PRODUCT CHANGE NOTIFICATION

Bourns® 1800 Series Signal Surge Protective Devices

Wiring Connector Component Change

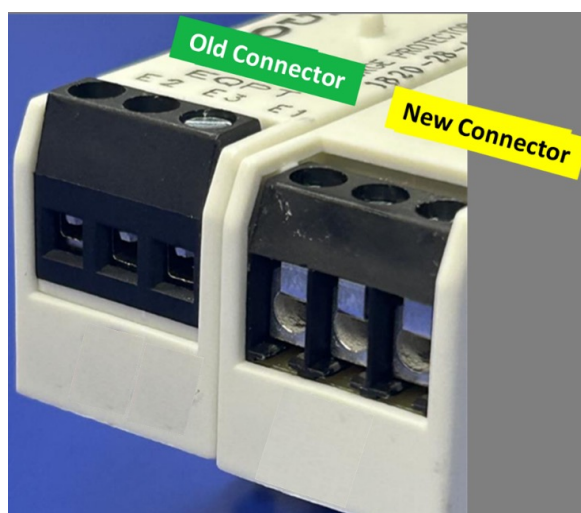
Riverside, California – November 6, 2025 – Bourns announces that, effective immediately, the design of the wire terminal connector for the 1800 Series Signal Surge Protective Devices (SPDs) will be updated. The change is being implemented due to the End of Life (EOL) of the current wire terminal connector by the current supplier. Bourns will implement a design update to incorporate a new equivalent connector. The new supplier has been qualified and included in the Bourns Authorized Vendor List. A list of affected part numbers is included below.

As shown in the image above, the form and fit of the connector will change slightly due to the new connector having a different design. The function, quality, and reliability of the connector will not be affected by this change. Traceability will be maintained through date code (1125).
